# UNITED STATES PATENT AND TRADEMARK OFFICE

APPLICATION NO.	FILING DATE	FIRST NAMED INVENTOR	ATTORNEY DOCKET NO.	CONFIRMATION NO.
10/063,288	04/08/2002	Claes Wallen	47865.272600	2442

## Office Action Summary

## **DETAILED ACTION**

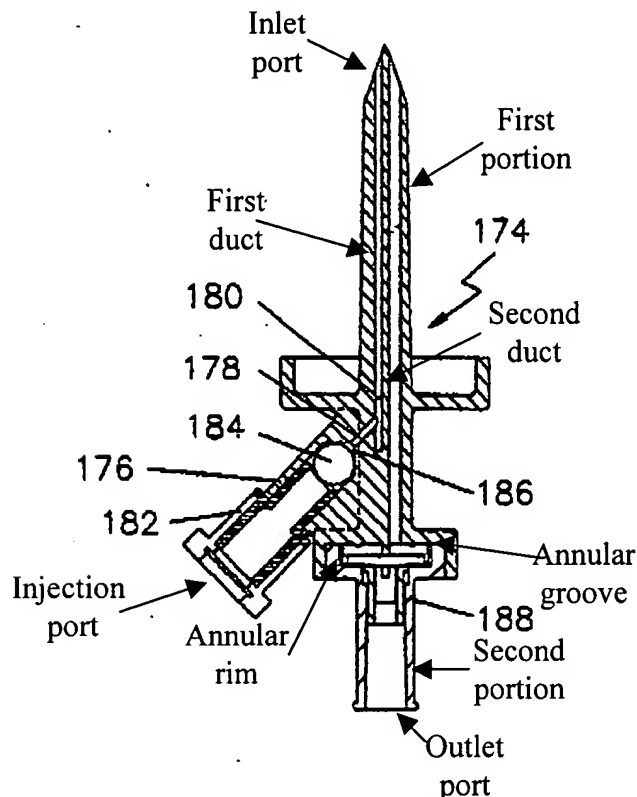
In the specification and figures, Richmond discloses the device as claimed by applicant. With regard to claims 1 and 9, Richmond discloses a device that is capable of mixing medical fluids comprising ports that may be used as an inlet port, injection port, and outlet port, respectively (see drawing, as annotated by Examiner, below, FIG 6). The device comprises a first duct 180 that extends between the inlet port and the injection port, and a second duct that extends between the inlet port and the outlet port (see FIG 6). The injection port comprises a hydrophobic, or fluid-proof membrane 182 that is capable of being penetrated by another device (see column 6, lines 18-53). The

device further comprises a first portion that houses the inlet port and the injection port

and a second portion that houses the outlet port. Richmond illustrates that the portions are separate through the use of diagonal lines, indicating that the portions may be made of different materials.
